**6571A-06A**

**S E R V I C E N O T E**

**6571A DC POWER SUPPLY MANUALLY CONTROLLED**

**The Current Shunt (Circuit Reference “R907”) may have intermittent sense wires, which may cause Instability of Current regulation, Current read back and current programming may become unstable.**

A6 Output Assembly for Models (65/6671A, 65/6672A)

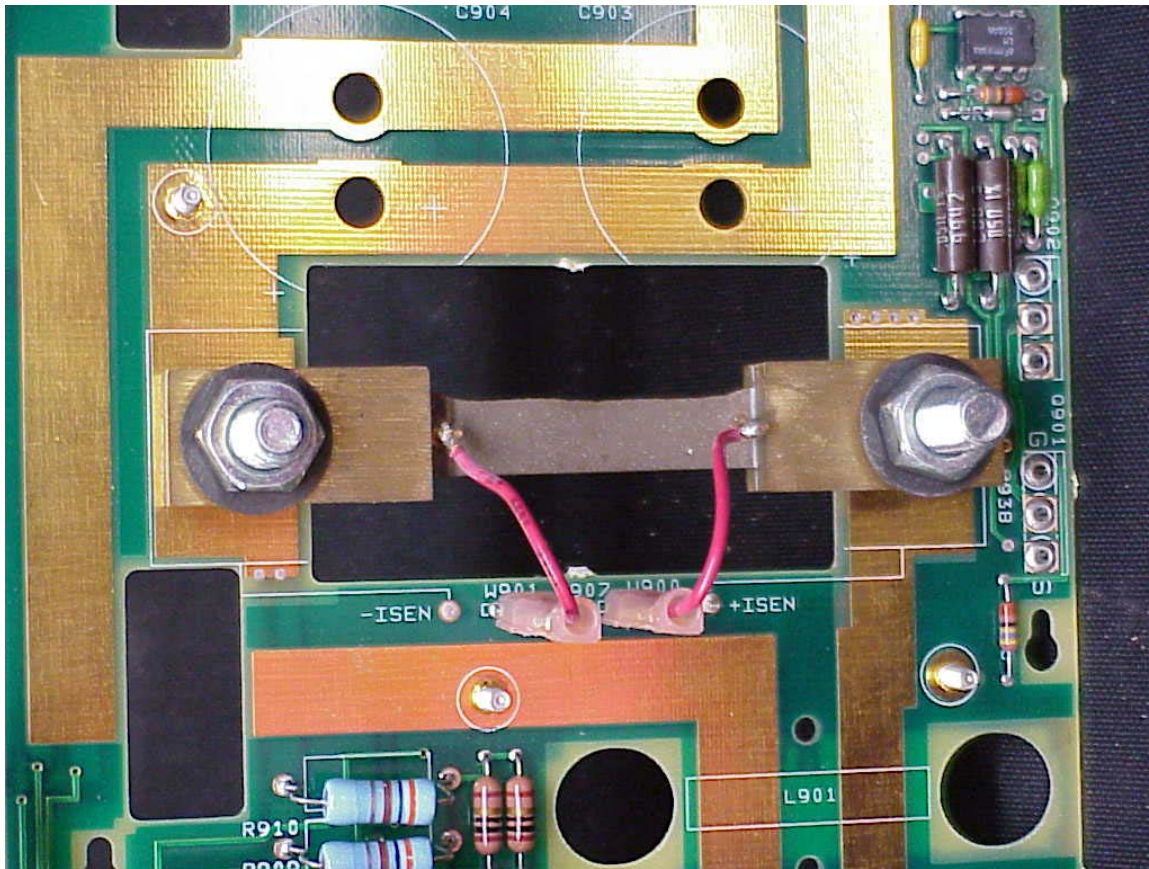
This picture shows how the Shunt R907 is connected using the term-crimp connectors.

The Shunt R907 is connected to "W900" & "W901"

Cut the terminal-crimp connectors off of both wires and discard the connectors. Make this cut as close to the terminal-crimp connector as possible. The required strip length should be 5mm. This strip length will be used to prevent the wire length being too long and shorting to the instrument chassis. If replacement of this wire is required any color (22 AWG, 300V 105C) wire type can be used.

This modification can be done from the top of the board. Carefully strip and solder the wires, and avoid burning the wire insulation and the printed circuit board.

The wires should be connected as shown below. The two holes marked -ISEN & +ISEN should be used. Do not cross the wires when making this modification. See picture below for details. This picture shows the required modification.
